APPENDIX D

Shawnigan Research Group (SRG) Information Submissions
May 31, June 08, June 13 & June 21, 2017

Response to MOE re Cobble Hill Holdings "As-Built" submission of April 18, 2017

Review - SHA Final Closure Plan

2.3.5 Engineered Filter Layer

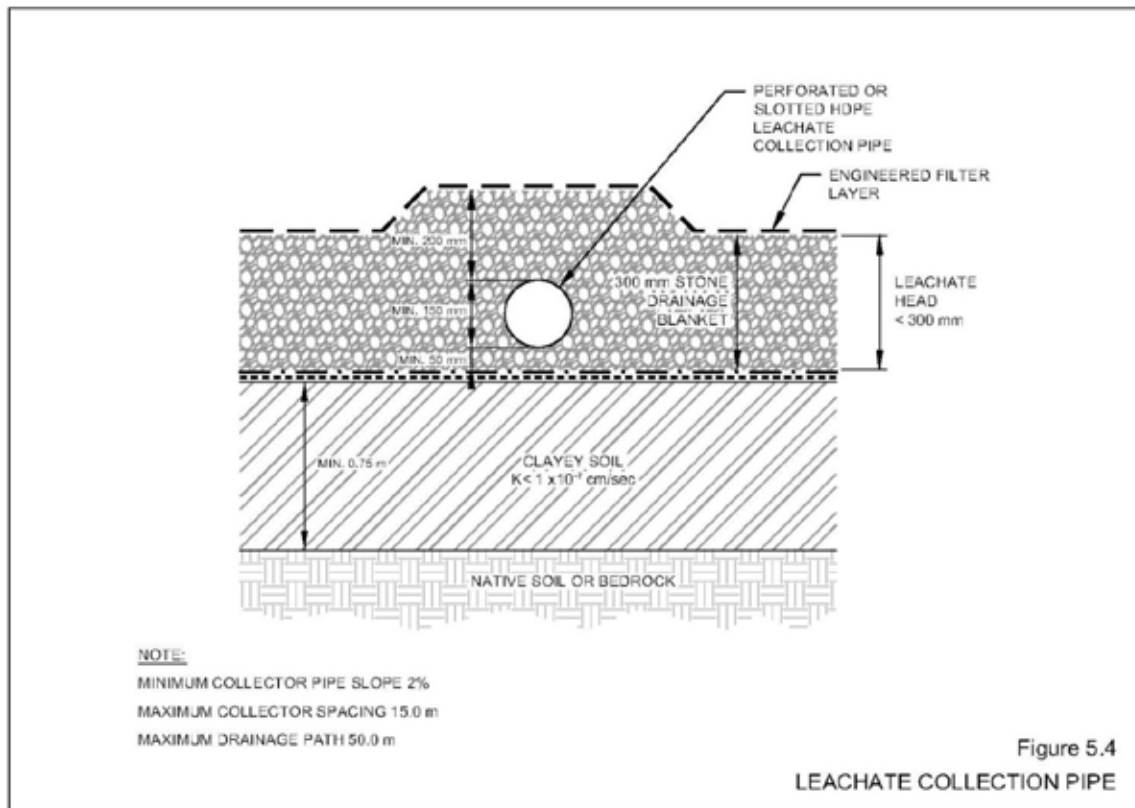
There is no mention in the DOX of the use of an engineered filter layer over the stone drainage layer.

Buffers

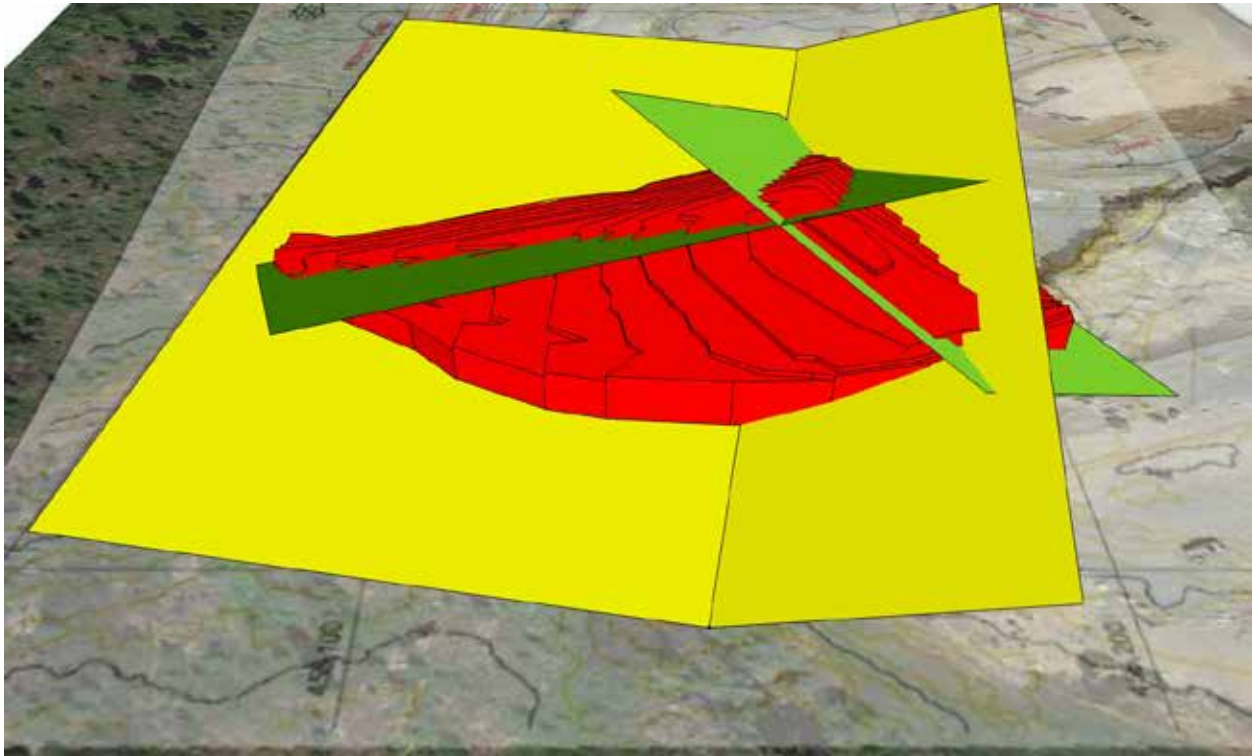
The SHA report makes no mention of the requirements in the "[Landfill Criteria for Municipal Solid Waste, Second Edition, June 2016](#)," or LCMSW, for buffers.

The landfill must be 50 m from the property line.

In addition, where the neighbouring property is a Regional Park, the buffer must be 100 m.
